April 19, 1982

SUBJECT: Modification of Female Keyboard Connector

581-228-SB1

FIELD ENGINEERING
COMPUTER SYSTEMS
TECHNICAL BULLETIN

FIGURE 1

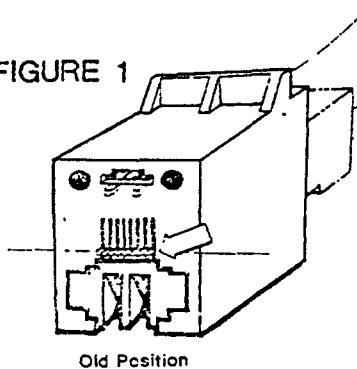
Modification insures proper placement and tracking of contacts within the connector, preventing a particular contact from egressing from its position.

1. Turn system off and unplug A.C. cord.
2. Following Level 1 Procedures, remove the P/S Sub-Assy. from the main-frame.
3. Reinstall keyboard in C.P.U. board.
4. Viewing female keyboard connector from the rear, with the keyboard male connector installed, note the position of the contacts as they protrude through the rear of the female connector (See Fig. 1). (Contacts should be near the bottom of the alignment channels, protruding approximately $3/64$ of an inch).
5. Using a spring hook, lift each contact individually and reform the contact to insure that in its home position with keyboard connected, the ends of the contacts appear as in Fig. 2.

FIGURE 2

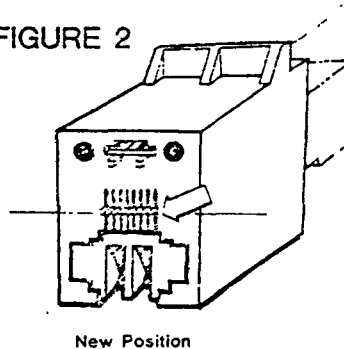
Note: When lifting each contact, exercise caution not to deform the plastic channels of the female connector. At no time should the spring hook be inserted in these channels. (See Fig. 3 for proper method of lifting contacts with spring hook).

FIGURE 2
PART # X-100670

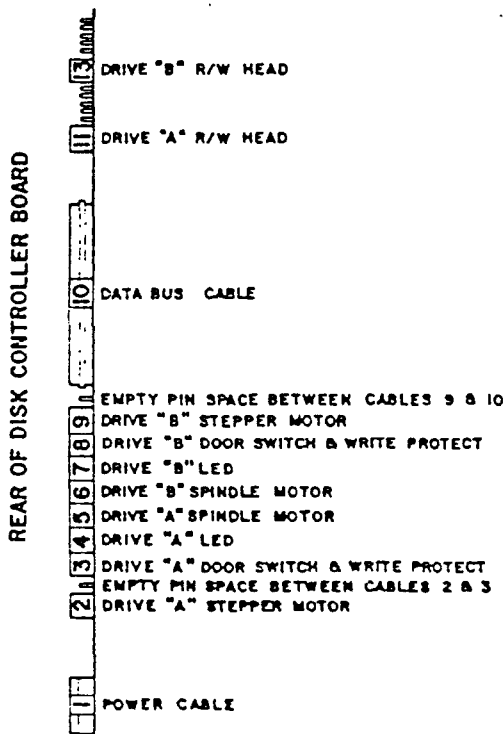
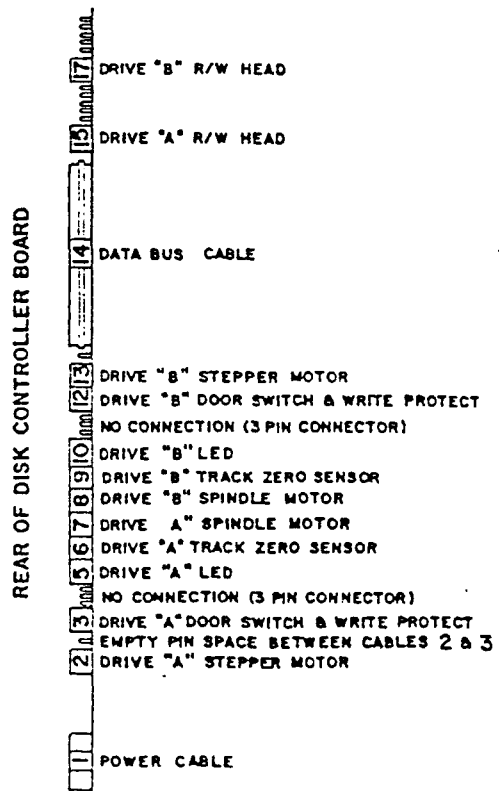
WHEN REPLACING AN OLD STYLE DISK DRIVE BOARD (PART # X-100093) WITH THE NEW STYLE DISK DRIVE BOARD, (PART # X-100670) THE CONNECTORS MUST BE RECONFIGURED. THE NEW STYLE BOARD IS DISTINGUISHED BY THE ADDITION OF A 4 PIN CONNECTOR (J19). J19 IS LOCATED ON THE RIGHT SIDE OF THE BOARD AS VIEWED FROM THE FRONT OF THE UNIT. THE CONNECTOR CONFIGURATIONS ARE AS FOLLOWS:

3- INSTALL NEW DISK DRIVE BOARD FOLLOWING LEVEL 1
MAINTENANCE PROCEDURES AND FIGURE 2. INSTALLATION FOR
CONNECTORS J6 AND J9 ARE AS FOLLOWS:

- A. IF DRIVE (A) HAS THE TRACK ZERO SENSOR, INSTALL
CONNECTOR FROM SENSOR TO J6.
- B. IF DRIVE (A) DOES NOT HAVE THE TRACK ZERO SENSOR,
A SPECIAL CONNECTOR MUST BE INSTALLED TO J6. THIS
CONNECTOR SHORTS PINS 2&3.

- A. IF DRIVE (B) HAS THE TRACK ZERO SENSOR, INSTALL
THE SENSOR CONNECTOR TO J9.
- B. IF DRIVE (B) DOES NOT HAVE THE TRACK ZERO SENSOR,
A SPECIAL CONNECTOR MUST BE INSTALLED TO J9. THIS
CONNECTOR SHORTS PINS 2&3.

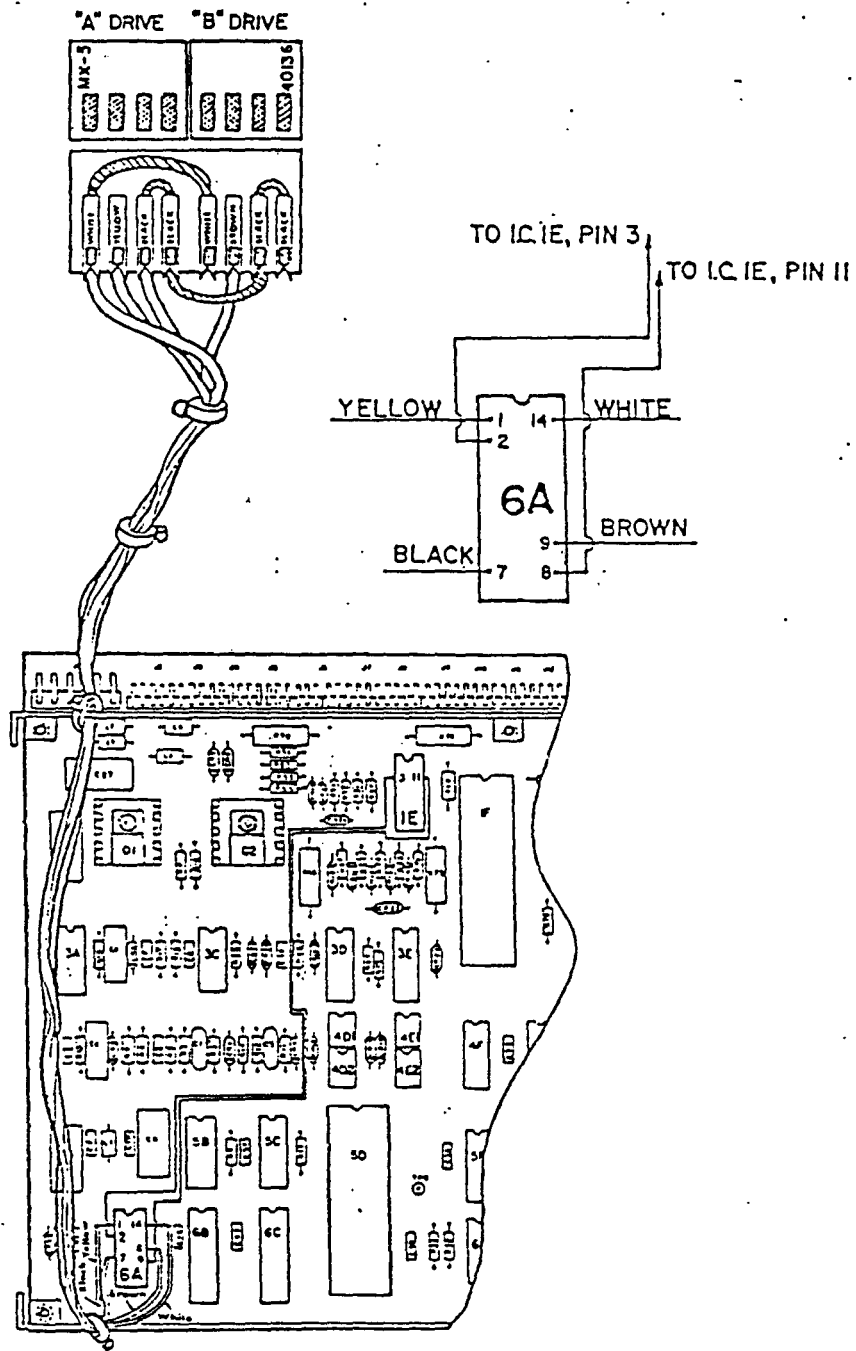
The X-100094 disk drive controller board should be updated with the Track Zero Harness (part # E-100979-01) any time maintenance is performed on the board. The harness update should be performed in the service center, not at the customer site.

1. Install a jumper from pin 2 of the IC at 6A (74LS14) to pin 3 of the IC at 1E (7406).
2. Install a jumper from pin 8 of the IC at 6A to pin 11 of the IC at 1E. Once the jumpers are routed, they should be bonded to the board with epoxy cement.
3. Install the harness as follows:
 1. Install the yellow wire to pin 1 of the IC at 6A.
 2. Install the black wire to pin 7 of the IC at 6A.
 3. Install the brown wire to pin 9 of the IC at 6A.
 4. Install the white wire to pin 14 of the IC at 6A.
 5. Tie-wrap the harness to the board as per illustration.

When installing the track zero sensor connectors to the harness, the yellow wire side of the harness is the A drive. The brown wire side of the harness is the B drive.

384K MEMORY BOARD

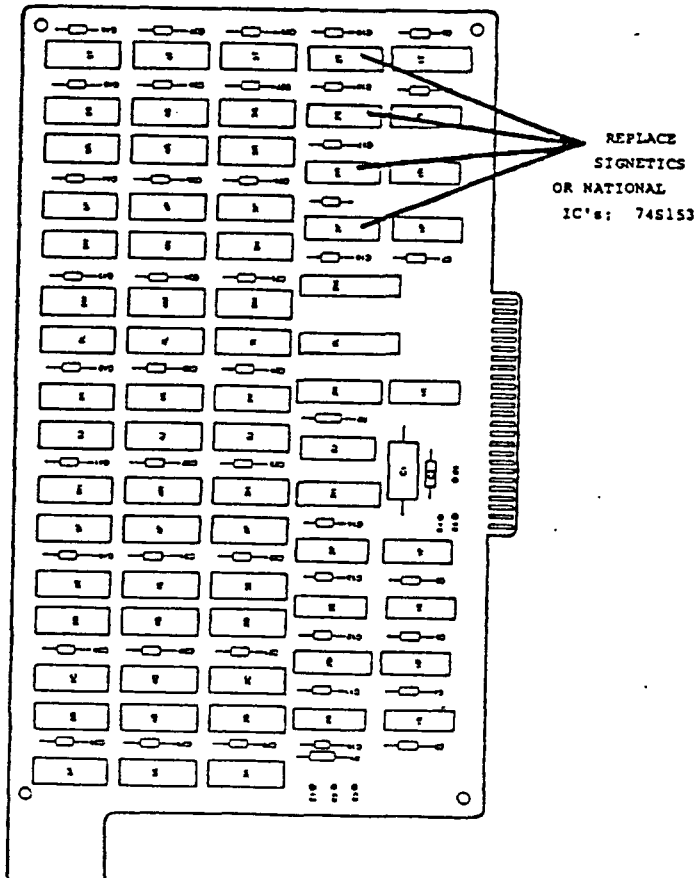
Ram memory board failure may be caused by Signetics or National ICs (74LS153). Replace the National or Signetics ICs in locations 2P, 2R, 2S, and 2T with:

TEXAS INSTRUMENTS 74LS153 (p/n 100858 .01)

CP/M 80 CARD REWORK INSTRUCTIONS

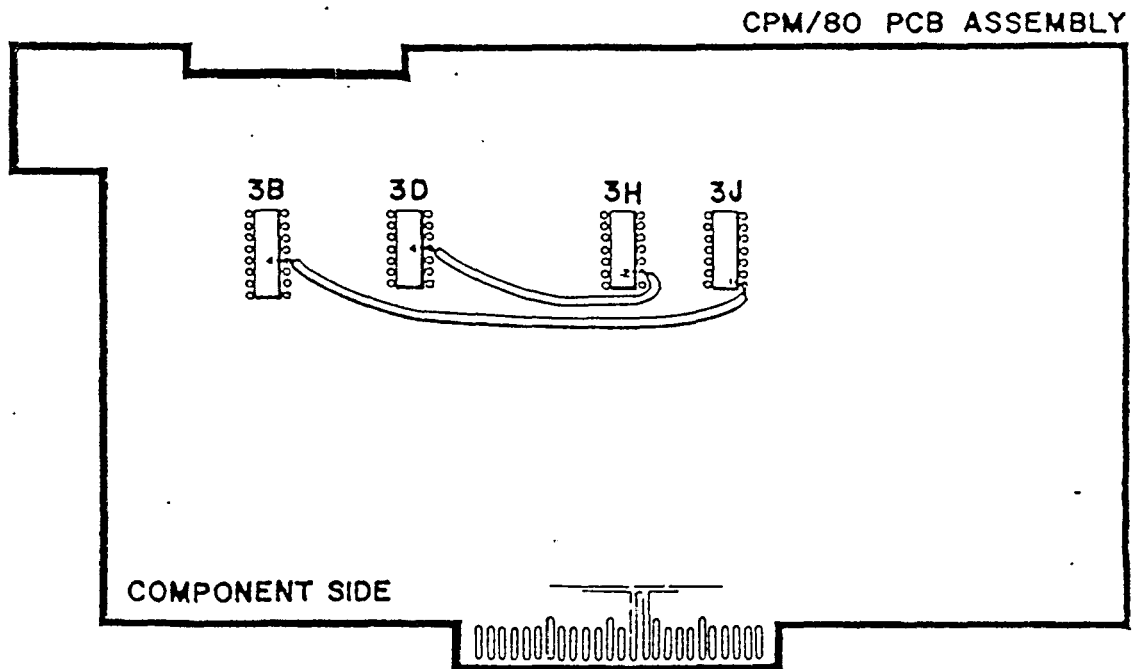
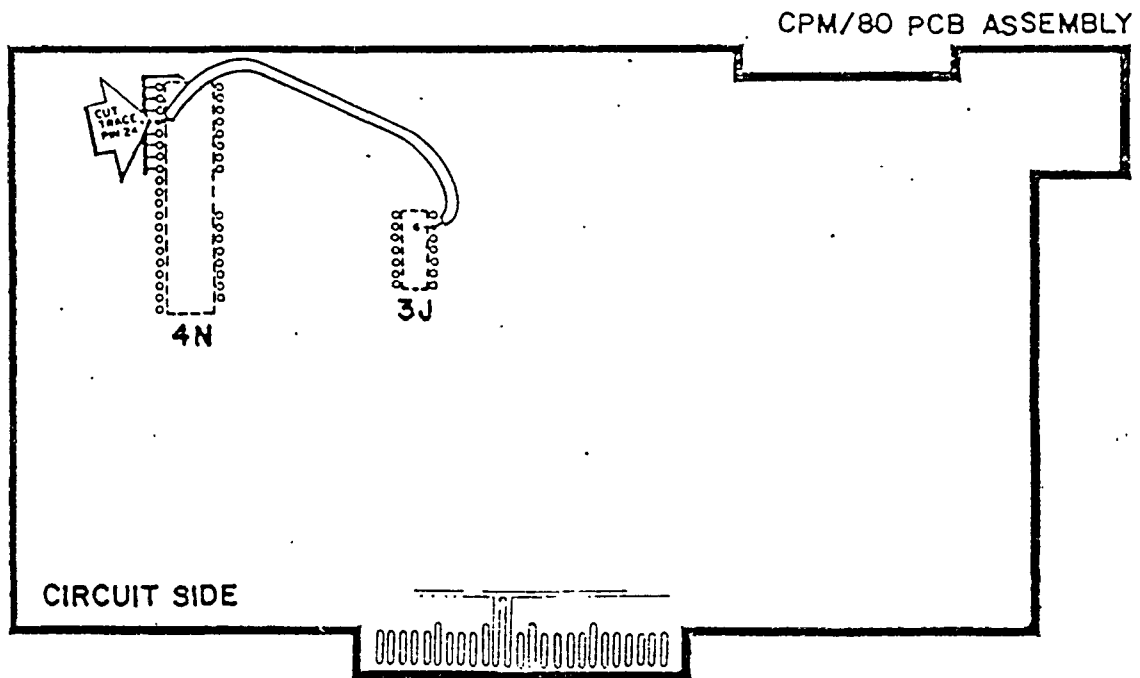
The FCO blue dot level "A" CP/M 80 cards must be upgraded to insure proper PROM memory access times are met. This bulletin will change the CP/M 80 card circuitry to add a wait state to the memory access cycle and change the PROM to a faster version.

1. At IC 3D. Cut pin 4 and lift it away from board
2. At IC 3J. Cut pin 1 and lift it away from board
3. Using 30 guage KYNAR wire part #100865-10.
 - A. Add a jumper from IC 3D pin 4 to 3H pin 2.
 - B. Add a jumper from IC 3J pin 1 to 3B pin 4.

1. CUT TRACE AT IC 4N

2. USING 30 guage KYNAR WIRE (PART # 100865-10), add jumper from IC 4N pin 24 to 3J pin 3.

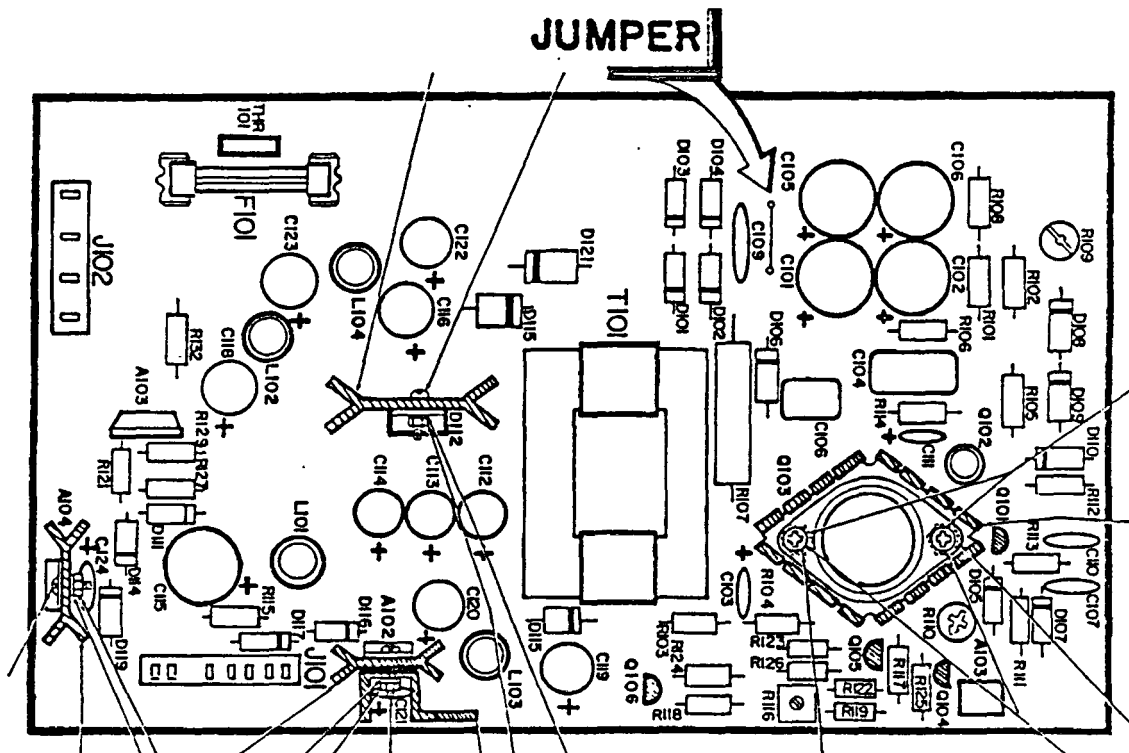
To convert the VICTOR 9000 from 230 VAC to 115 VAC, a jumper must be installed on the power supply. The jumper should be installed in parallel to capacitor C109. See drawing for jumper location.

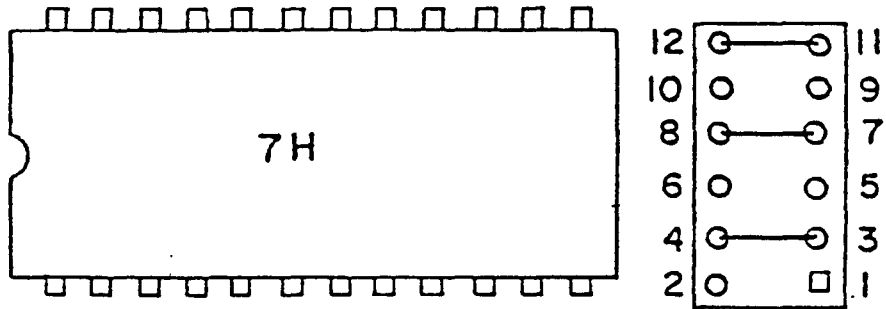
1. Remove BOOT PROM (Part #E-100716-01 or E101135-01) at location 7H and BOOT PROM (Part #E-100715-01 or #E-101134-01) at location 5H.
2. Install 64K BOOT PROM (Part #E-101171-01) at location 7H.
3. Install a jumper at locations:
E3-E4
E7-E8
E11-E12
4. Remove jumper at locations:
E1-E2
E5-E6
E9-E10

FIG. 2

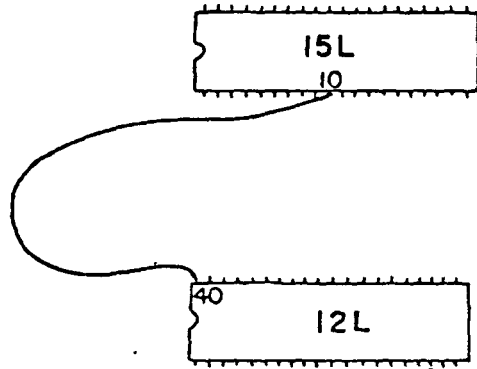
Add a jumper wire from IC 15L pin 10 to IC 12L pin 40 (figure 2).

SUBJECT: CORRECTION OF CPU BOARD TIMING PROBLEM (REV H)

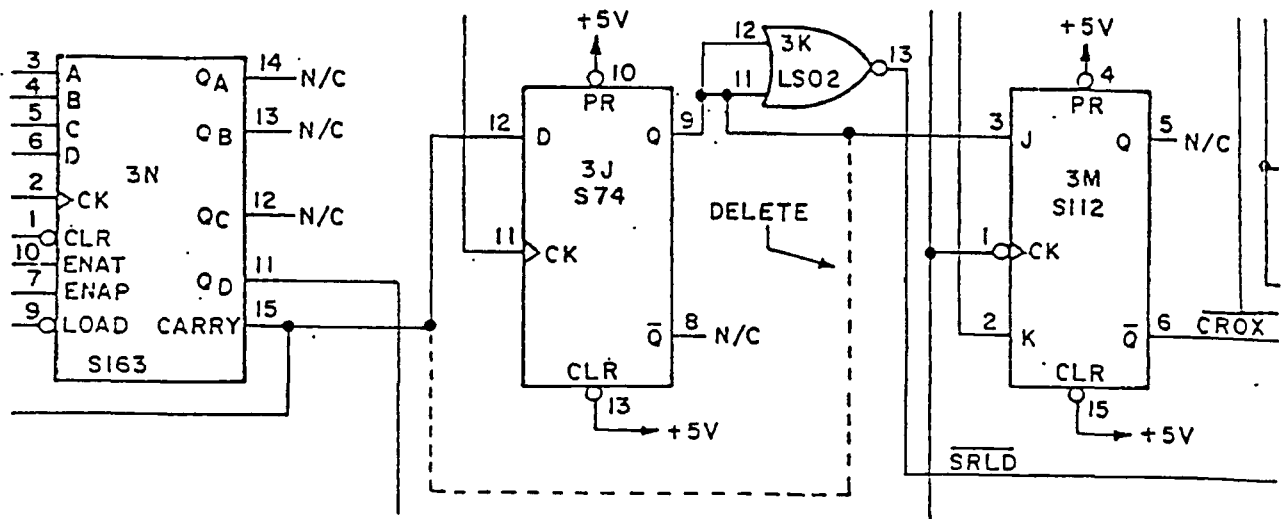
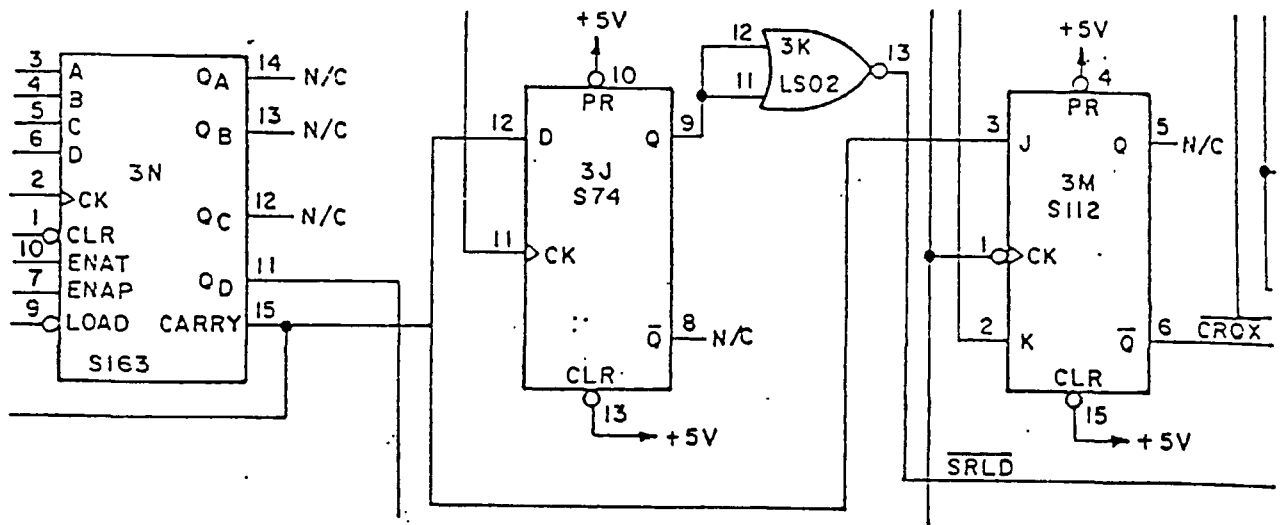
When loading the CPU board with more than two memory expansion cards, the display system may exhibit video jitter.

The CPU board should be removed and upgraded using the following procedure.

Figure 1 .

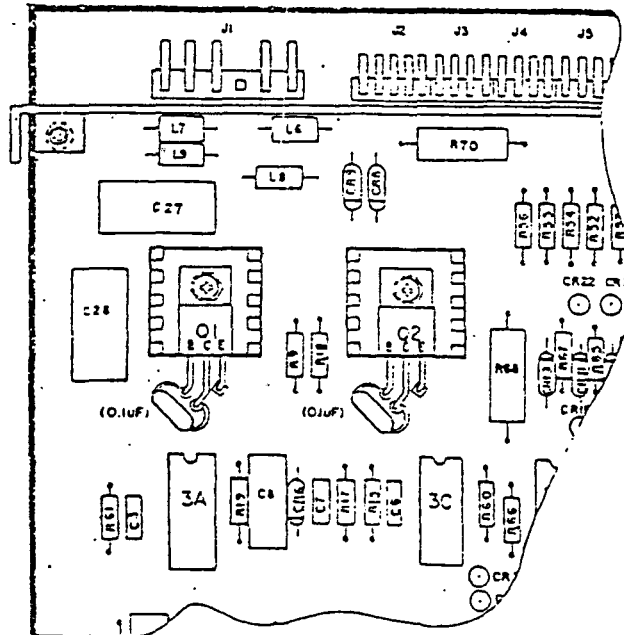
When a disk drive control board is repaired, it is advisable that a .1 uf capacitor (Part # E-100140-01) be added to the motor drive transistors at locations Q1 and Q2. The addition of these caps will reduce the noise generated by the transistors at turn on. The capacitors should be installed on the component side of the board from the base to the collector of both the transistors. See figure 1 for the installation of the capacitors.

Change the drive board FCO blue dot on # E-100670-01 and # E 100670-02 to F. Change the FCO blue dot on # E-100094-01 boards to D.

FIGURE 1

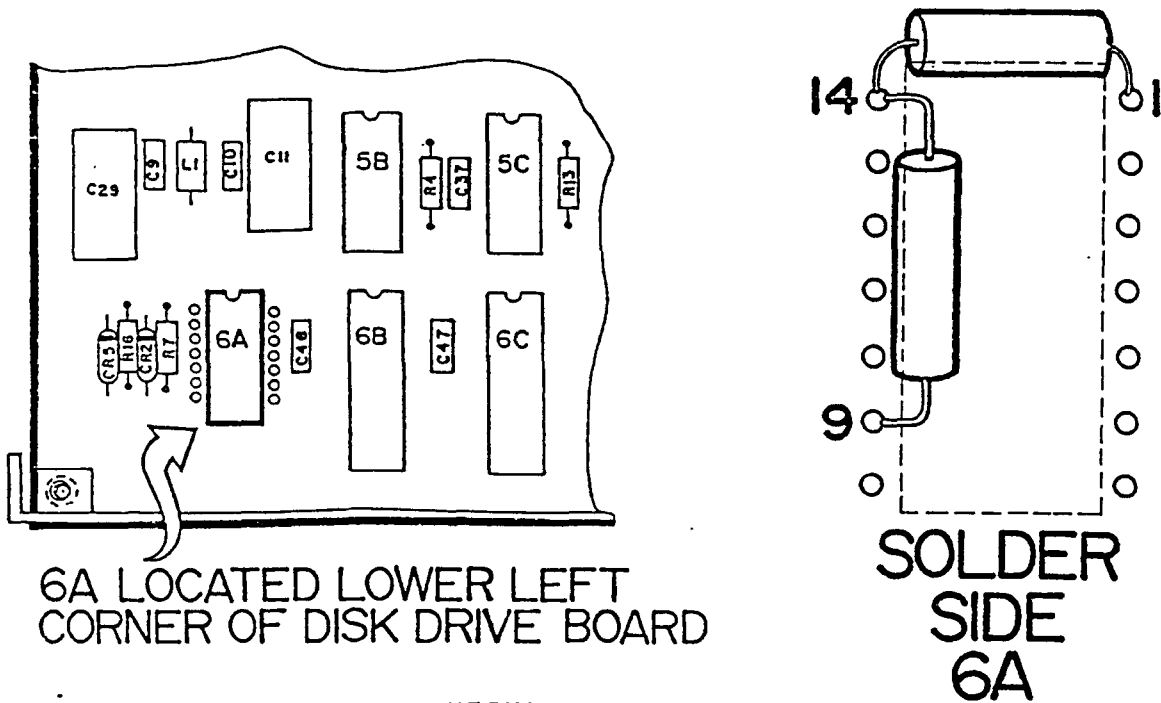
When an X-100094-01 controller board is repaired, add a pull up resistor to the track zero sensor circuit.

Two 10K 1/4 watt resistors (Part #0-052223-103) should be added on the solder side of the PCB. The resistors should be installed from Pin 1 to Pin 14 and from Pin 9 to Pin 14 on the IC located at 6A. Refer to figure 1 for the installation of the resistors.

Figure 1

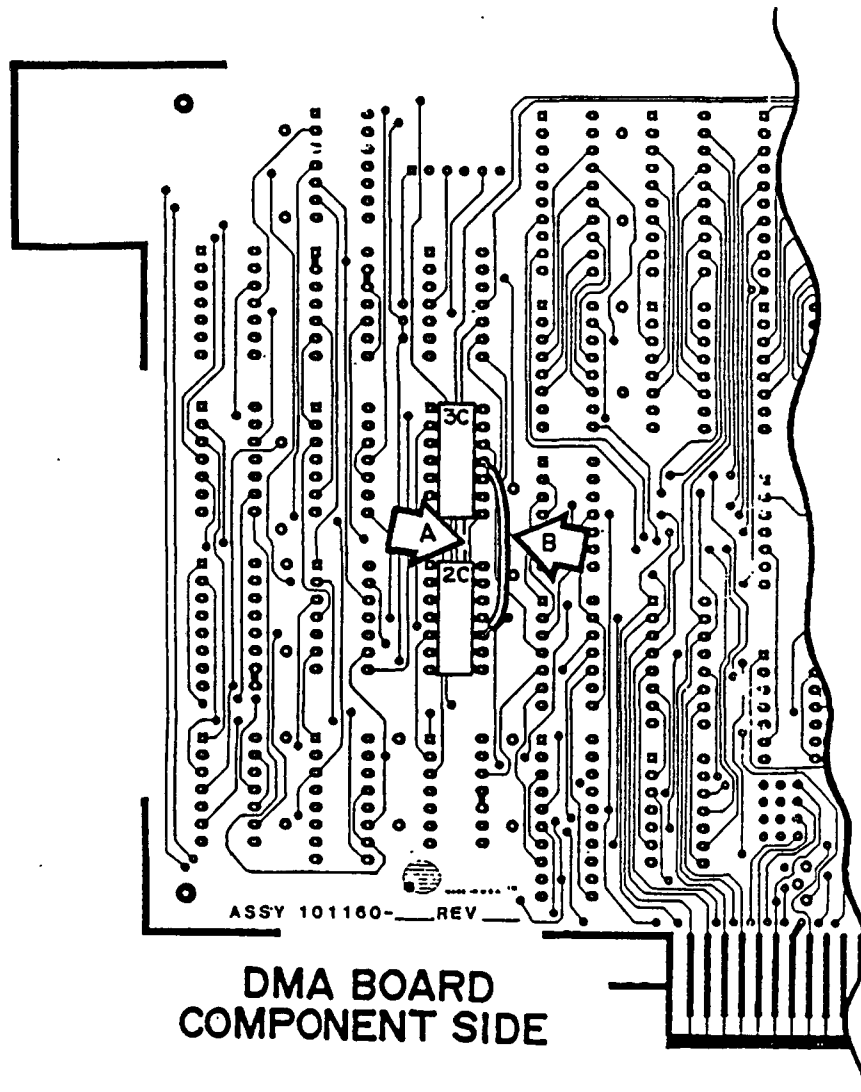
Rework the DMA Interface Board, correct the schematic, and change FCO Blue Dot character to "B", once rework is complete, as outlined on the following pages.

1. Cut trace from IC 2C Pin 8 to IC 3C Pin 11.
2. Add jumper from IC 2C Pin 10 to IC 3C Pin 11.
